Submissions Report and EIS Addendum

16-24 Lord Street & 21-27 Roseville Avenue

Prepared for: Hyecorp Property Group

SSD-78996460

Figure 4 Key Design Updates

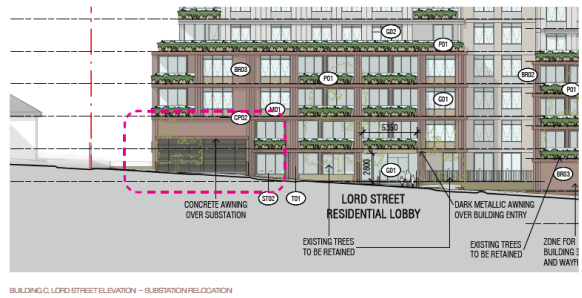
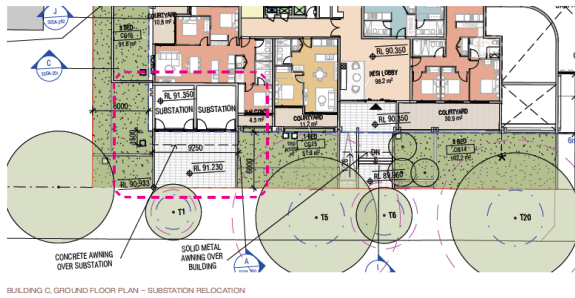
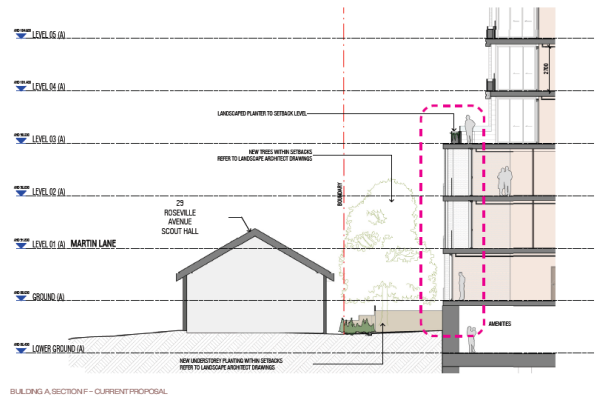
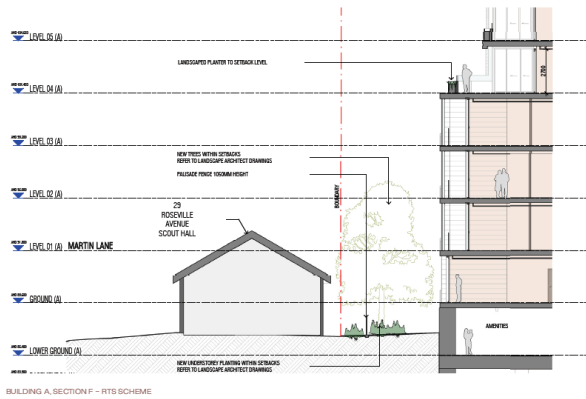
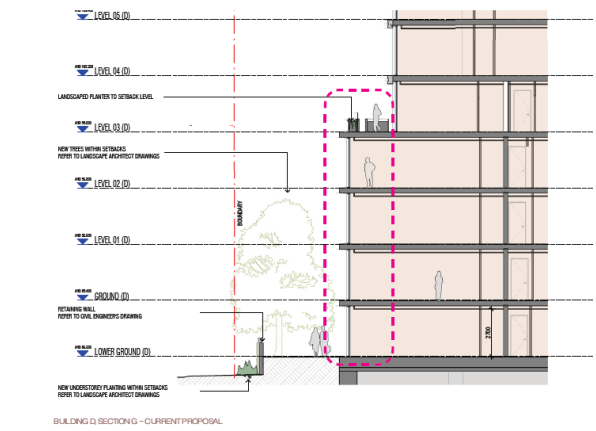
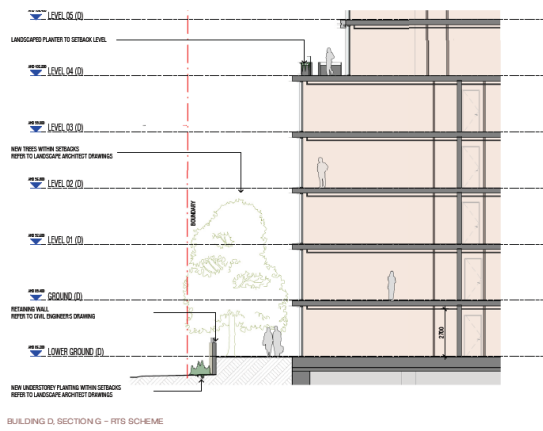
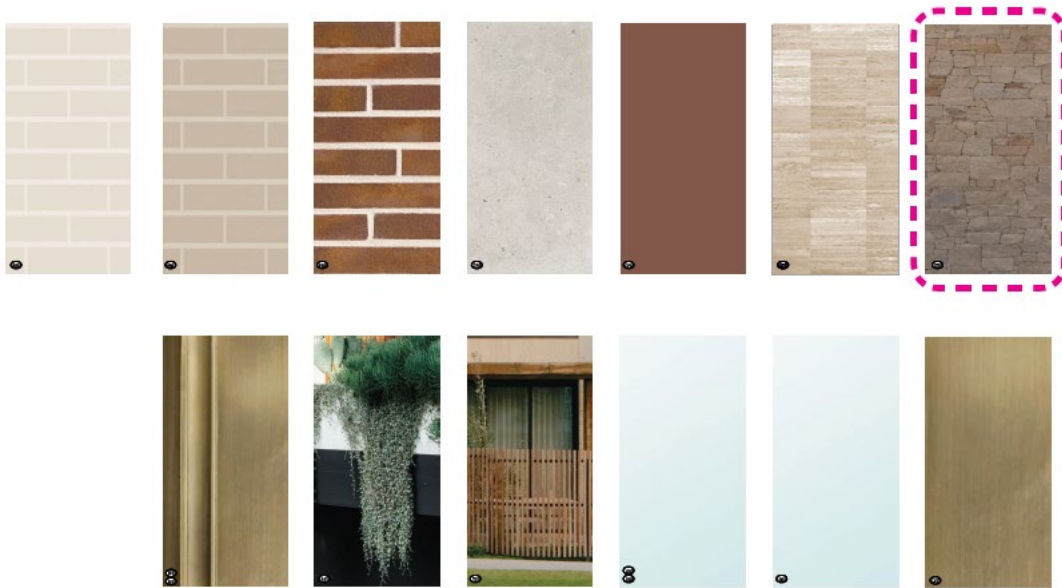
Authority	Position
DPHI RFI letter	<ul style="list-style-type: none"> ▪ Bulk and scale <ul style="list-style-type: none"> – Podium heights of Buildings A and D do not adequately respond to site topography or transition to the adjoining Scout Hall. Reduce overall podium heights and introduce additional stepping and articulation to improve scale transition and streetscape integration.

-
- Basement walls along Martin Lane and the eastern boundary present a strong visual edge to the public domain and Scout Hall interface. Reduce wall heights where feasible and revise materiality colour and detailing to soften visual impact

- Relocation of substation to eliminate the need for street tree removal on Lord Street;
- Reduction of Building A podium adjacent to the Scout Hall from 4 to 3 storeys;
- Reduction of the of Building D podium from 5 to 4 storeys;
- Replanning of apartment layouts to respond to building massing changes as described above;
- Substitution of previously proposed podium material for darker colour as requested by Council;
- DDA and affordable housing allocations recalibrated to respond to GFA changes and replanning of apartments.

Refer to the updated Architectural Plans (**Appendix D**) for further details on the design refinements made since re-exhibition. Extracts from the updated Architectural Plans identifying the key design changes are provided in the Figure below.

Figure 5 Surrounding future character

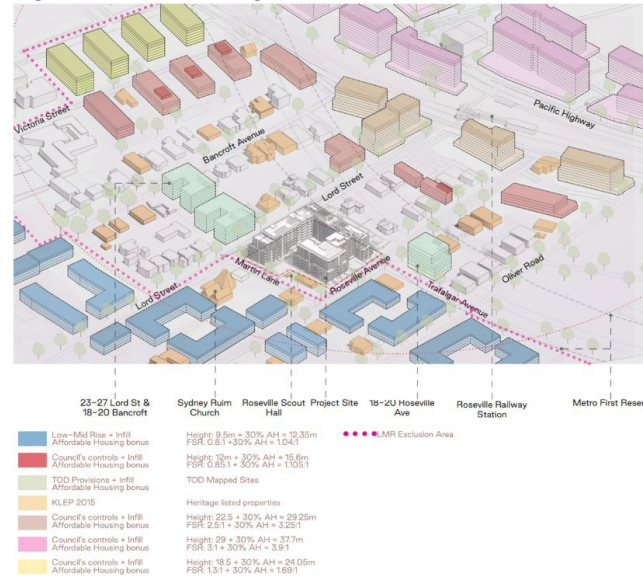
11. The Design Statement Addendum (p25) does not properly identify the desired future character within the LMR exclusion zone, specifically the neighbours along the western boundary. The map proposes the western neighbours will redevelop into RFBs despite the current development controls limiting this. Provide updated shadow diagrams	Updated shadow diagrams are provided within the Design Statement Addendum.	Design Statement Addendum Appendix E

As can be seen in **Figures 6 and 7** below, the reduced podium heights to Buildings A and D and change to the materiality improve the relationship of the proposal to the surrounding character. Whilst Council’s request for a minimum upper level setback 10m is acknowledged, increasing the upper-level setback by up to 1m would not be materially perceptible from the public domain. As such, it is considered that the 9m upper-level setbacks provided to all sides of the development will ensure appropriate setbacks are maintained to existing and potential future development on surrounding sites. It is also noted that the proposed upper-level setbacks are satisfactory to provide the required solar access and amenity to neighbouring single-storey dwellings.

Figure 8 ADG section 2G street setbacks (Figure 2G.4 extract)

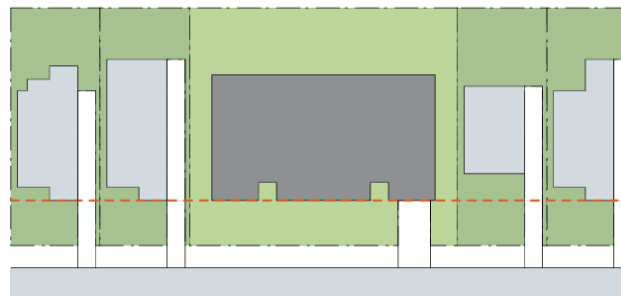
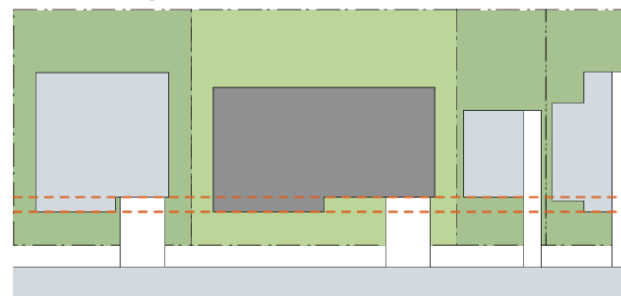
- Increase front setbacks along Roseville Avenue and Lord Street preferably to 10 metres
- Improve deep soil and canopy planting opportunities
- Reduce podium dominance and improve separation to heritage items
- Provide updated site plan showing deep soil zones
- Provide photomontages demonstrating reduced visual dominance

The ADG does not require that street setbacks be increased relative to a building's scale. This is demonstrated in the extract from the ADG below (**Figure 8**), where differing scales of development have a consistent street setback and front building line, defining the future streetscape.

Figure 9 Reduced hard surface treatments to Lord Street

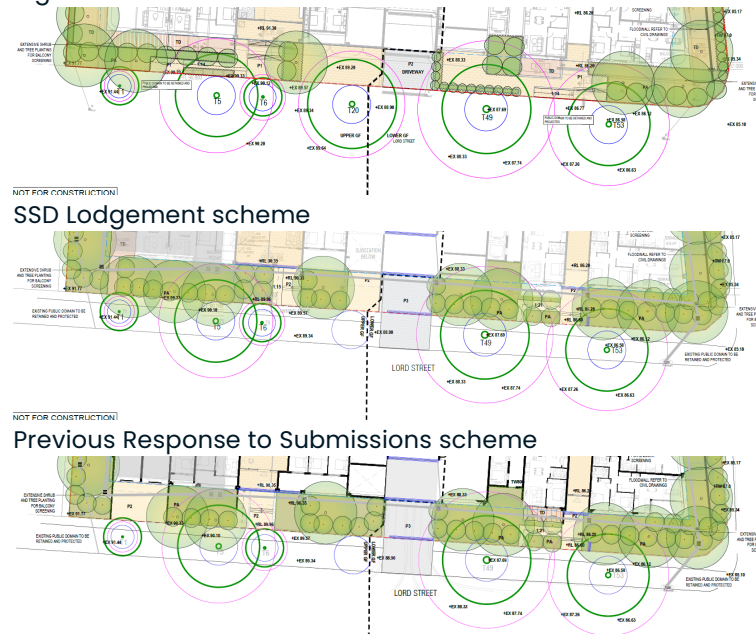
- The extent of hard surface treatments within the Lord St site frontage is uncharacteristic of the established landscape context and results in unnecessary tree impact to trees within the public domain. It is recommended the extent of BUA within the street frontage be significantly reduced and viable deep soil landscape area increased to maintain existing street trees.

surface are limited to the pedestrian and vehicular access and the access required to the substation in accordance with Ausgrid requirements. The relocation of the substation has enabled the retention of all street trees along Lord Street, which, along with the proposed landscape planting, screen and soften the appearance of the development. The landscape planting surrounding the access ways has been maximised and the widths of the access minimised as far as possible. The updated pattern of the access ways is reflective of the existing pattern of driveways within the street. Refer **Figure 9** below.

Figure 10 Updated Building Massing (East Elevation)

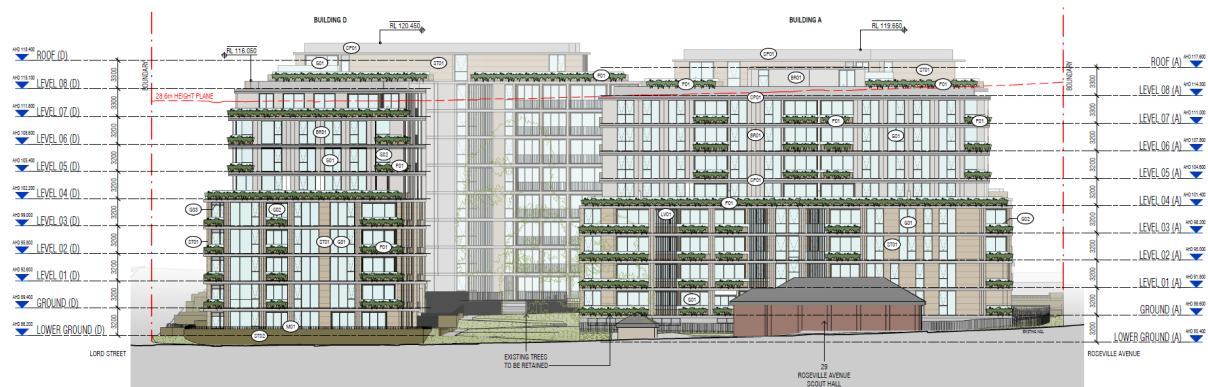
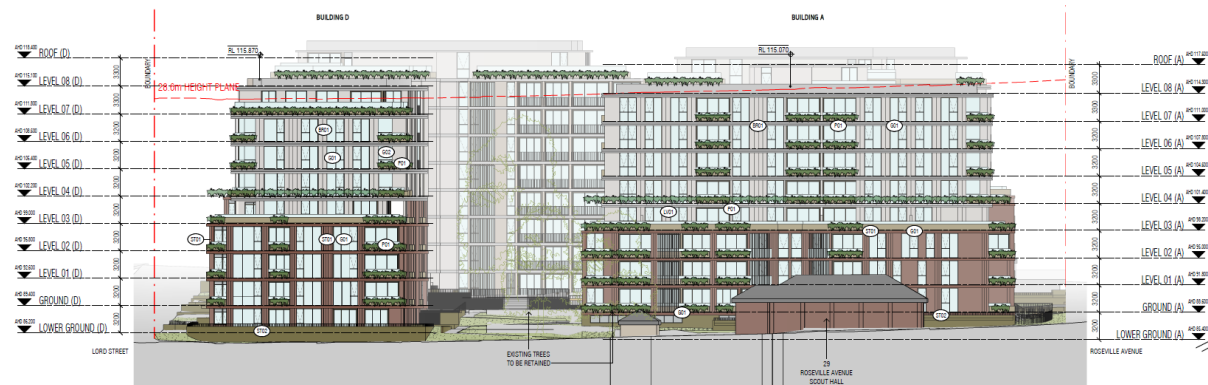
- **Inconsistent with aim**
 - Proposal not consistent with intent of Housing SEPP and context sensitive design outcomes.
 - Reduce perceived bulk and visual dominance from Roseville Avenue Lord Street and within the HCA.
 - Reduce podium scale at Scout Hall interface including lower height and increased upper-level setbacks.
 - Provide a clear context response statement tied to actual streetscape pattern heritage rhythm and scale transition.
- **Failure to meet Schedule 9 design principles**
 - Proposal does not adequately respond to contextual design principles.
 - Provide a design principles response pack demonstrating compliance with each principle
 - Include streetscape elevation comparisons existing and proposed
 - Provide view corridor and visual sensitivity mapping from key HCA locations
 - Provide massing evolution diagrams showing how design changes reduce impacts

- Remove exposed basement walls
 - **Setbacks and built form**
Podium height and setbacks do not reflect heritage context
 - Reduce podium scale
 - Increase separation from Scout Hall

The updated proposal has considered the site's context in relation to the massing of the building and its relationship with neighbouring properties. The bulk and scale have been minimised through reducing the podiums of Buildings A and D by one storey, to three and four storeys respectively. This reduction in the podium heights provides for an improved relationship with the neighbouring Scout Hall, as well as existing dwellings and potential future four-storey development to the east. The reduction in the podium heights also increases the number of storeys setback 9m from the site boundary, providing more 'breathing room' to the heritage listed Scout Hall.

Figure 11 Updated materials and finishes

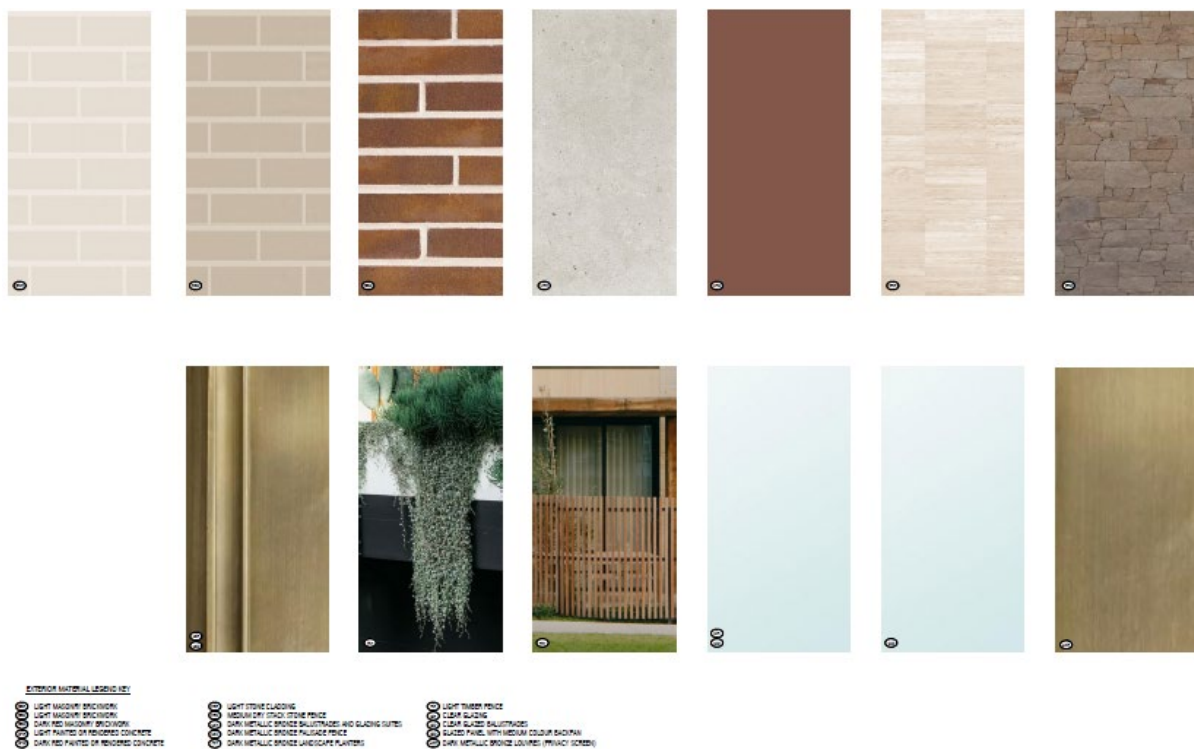
- **Landscape loss**
Loss of landscape character and canopy
 - Increase deep soil and tree retention
 - Improve planting outcomes
 - **Materials and colours**
Material palette not consistent with heritage character

- Replace light podium materials with darker earthy tones
 - Ensure podium reads as recessive and compatible with HCA

The updated proposal has responded to the Federation-period character of the locality and the Clanville Heritage Conservation Area. The proposed materials palette has been amended to include a dark material on the podium façades and the inclusion of darker brown and bronze tones to provide more contrast to the taller elements of the building. The use of darker brick for the building podium provides a more sympathetic responses to the character of the local area, reflecting the materials palette of existing residential dwellings. This creates an improved relationship of the base

of the building with the scale of existing surrounding properties. It also results in a greater contrast with the upper setback levels of the proposed building, so that they appear more recessive.
